Report: TAB Report
Function: Test, Adjust, & Balance
Date: 11/14/2024
Completed By: National TAB

PROJECT
11-11-24 WAWA #5452 ORLANDO, FL

Project: 11-11-24 WAWA #5452 ORLANDO, FL

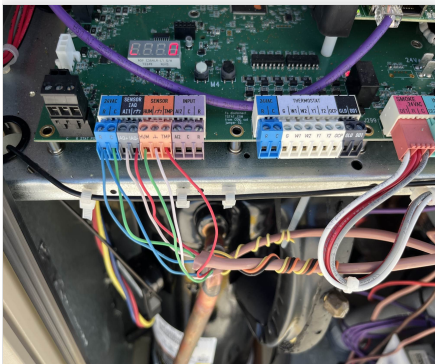
Issue Name : EF-1 Missing Backdraft Damper
Description : There is no backdraft damper installed in the EF-1 drop.
Created By : National TAB **Assigned To :** National TAB - Stephen Tassinaro
Status : Open
Priority : Medium **Asset Tag :**
Originated Date : 11/13/2024 - Stephen Tassinaro - National TAB

- **11/15/2024 National TAB - Stephen Tassinaro**
 - Unable to confirm if backdraft damper was added when curb adapter was installed. Fan was jammed onto the curb adapter and NTi tech was unable to separate without risking damage to fan.

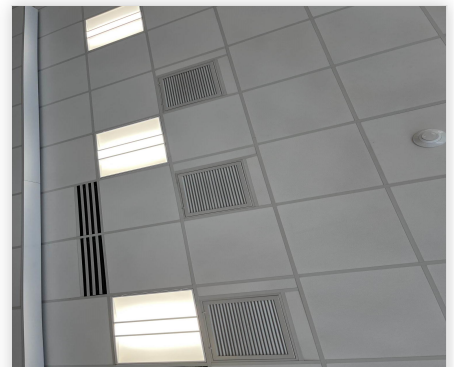
Issue Name : RTU Return Grille Sizing
Description : All RTUs call for G-1 return grilles. A G-1 air device is specified to have a 20"x20" neck and a face size of "NECK+3-3/4". The installed grilles are undersized and measure ~17"x17", with an open area of ~15.5"x15.5".
Created By : National TAB **Assigned To :** National TAB - Stephen Tassinaro
Status : Open
Priority : High **Asset Tag :**
Originated Date : 11/14/2024 - Stephen Tassinaro - National TAB

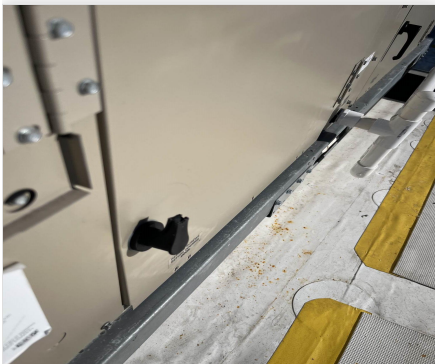
Issue Name : RTU-1 Broken Handle
Description : RTU-1 has a broken handle on the filter access door. Recommend replacement.
Created By : National TAB **Assigned To :** National TAB - Stephen Tassinaro
Status : Open
Priority : Low **Asset Tag :**
Originated Date : 11/13/2024 - Stephen Tassinaro - National TAB
